9 November 2021

Oakdale West Industrial Estate Stage 3 (SSD 9794683) – Amended Development Application

Figure 2: Revised site plan – Building 2A (Source: SBA Architects)

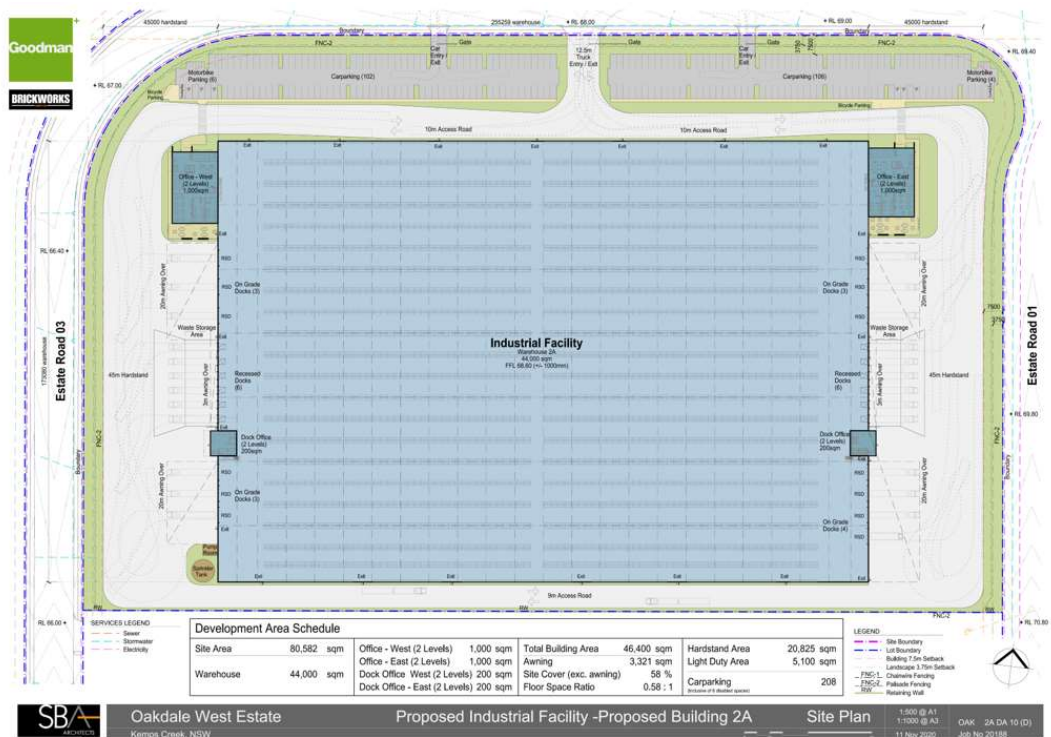
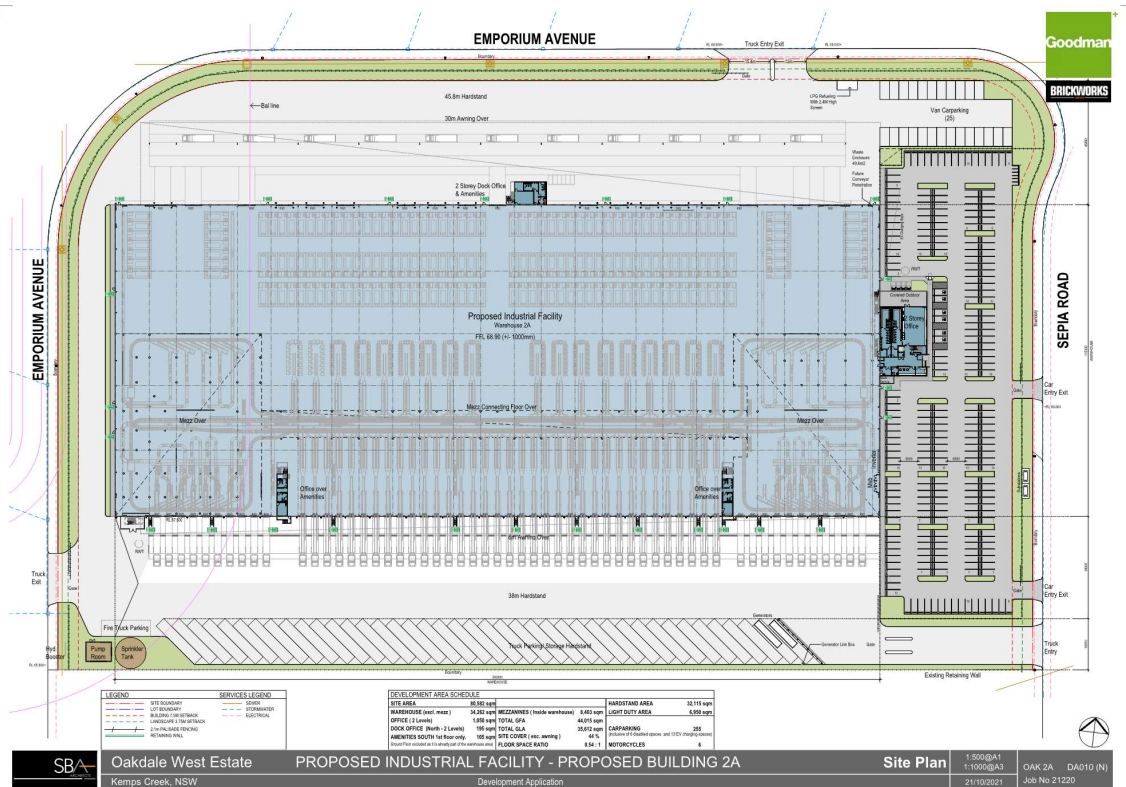
The tenant for Building 2A intends to use the warehouse for parcel processing and distribution. The key proposed amendments to Building 2A include:

- 14% reduction in site coverage (from 58% to 44%)
- 9,738 square metre (m²) (22.1%) reduction in warehouse building footprint (from 44,000 m² to 34,262 m²) and additional 8,403 m² mezzanine

- 2,385 m² (5.1%) reduction in overall Gross Floor Area (GFA) (from 46,400 m² to 44,015 m²)
- 10,788 m² (23.3%) reduction in overall Gross Lettable Area (GLA) (from 46,400 m² to 35,612 m²)

- 1.2 m reduction in ridge height (from 14.9 m to 13.7 m)
- Changed access for car and truck entry/exit points
- Peak traffic generation occurring outside the estate network peak periods of 7 am to 8 am and 5 pm to 6 pm, changing to 5 am to 7 am and 9 pm to 11 pm

- 47 additional car parking spaces (from 208 to 255 spaces) and repositioning of the carpark to the eastern side of the site
- Use of temperature control at the southern dock with units placed on the warehouse roof

A comparison of the amended project compared with the project as submitted in the EIS from February 2021 is summarised in Table 1 and shown in Figure 1 and Figure 2.

Figure 4: Amended site plan providing revised access to Building 2D carpark (Source: SBA Architects)

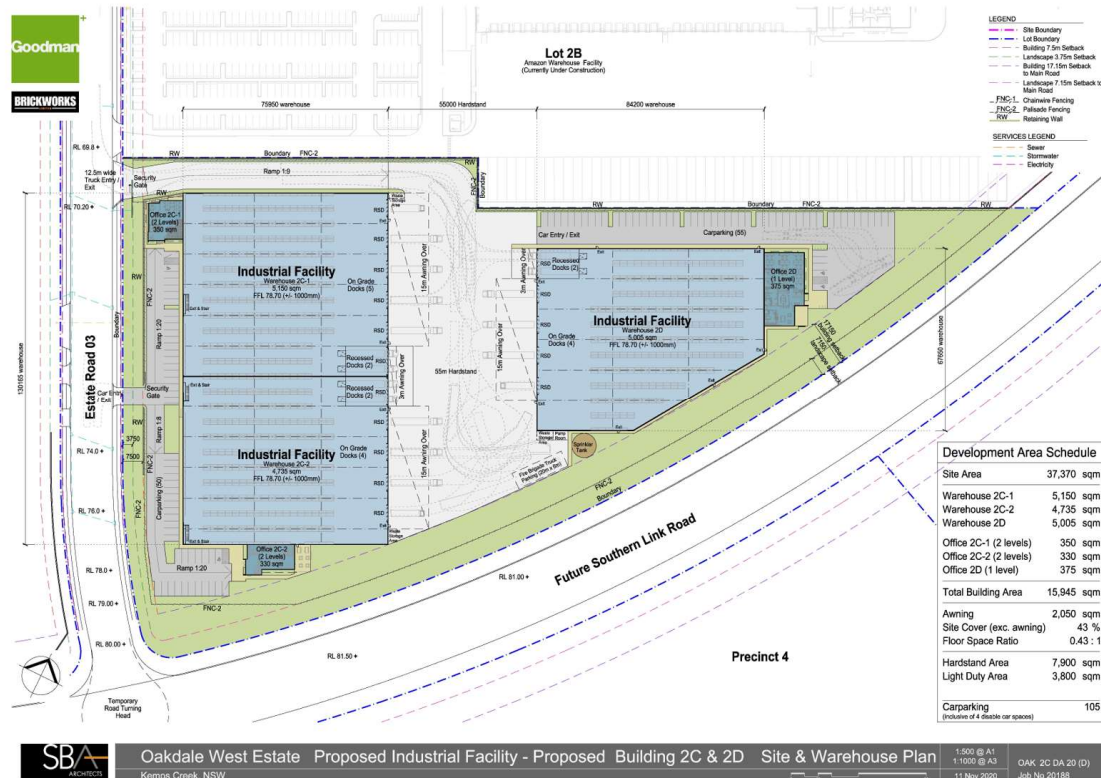
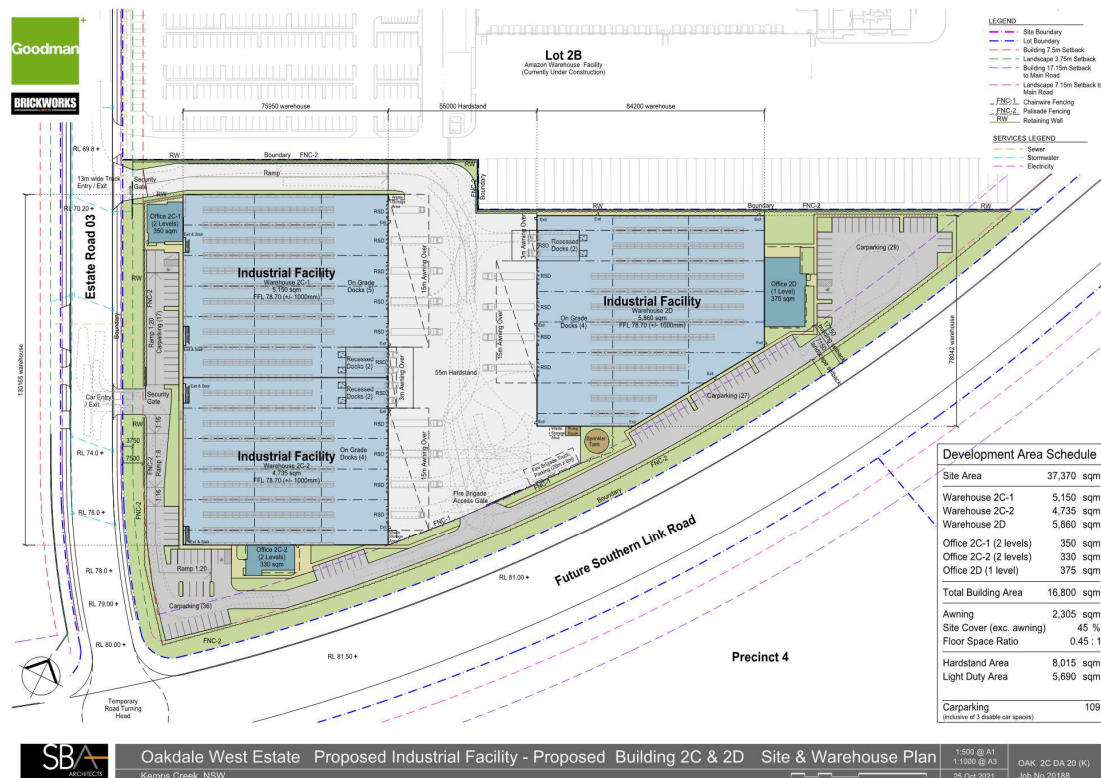
The Department notes that a shared light and heavy vehicle driveway is proposed for access to the Building 2D car park. The Department agrees with Council that this has potential traffic safety impacts along the driveway and within the loading dock area. It is requested that an alternative access arrangement be provided for light vehicles to the car park, noting that landscape setbacks along each boundary must be maintained.

Figure 3 shows the originally proposed site and warehouse plan, with shared access for heavy vehicles and light vehicles accessing the carpark for Building 2D. Figure 4 shows the revised scheme whereby access to Building 2D car parking is provided via the same driveway which accesses parking for Building 2C.

The amended access to car parking for Building 2D reduces any potential for conflicts between truck and car movements. The revised access requires the provision of an access driveway and parking along the southern boundary of the lot. The access driveway does not encroach into any required setbacks, including landscaped.

The proposed amendments include a 2% increased overall site coverage (from 43% to 45%) with 3 additional car parking spaces (from 50 to 61 spaces) at Buildings 2C1 and 2C2. The proposed amendments to Building 2D include:

- an 855 m² (17%) increase in building footprint (from 5,005 m² to 5,860 m²) and corresponding 855 m² (16%) increase in overall GFA/GLA (from 5,380 m² to 6,235 m²)
- one additional car parking space (from 55 to 56 spaces)

The Applicant has considered the Department's comments and has amended the proposed access and parking arrangements for Building 2D.
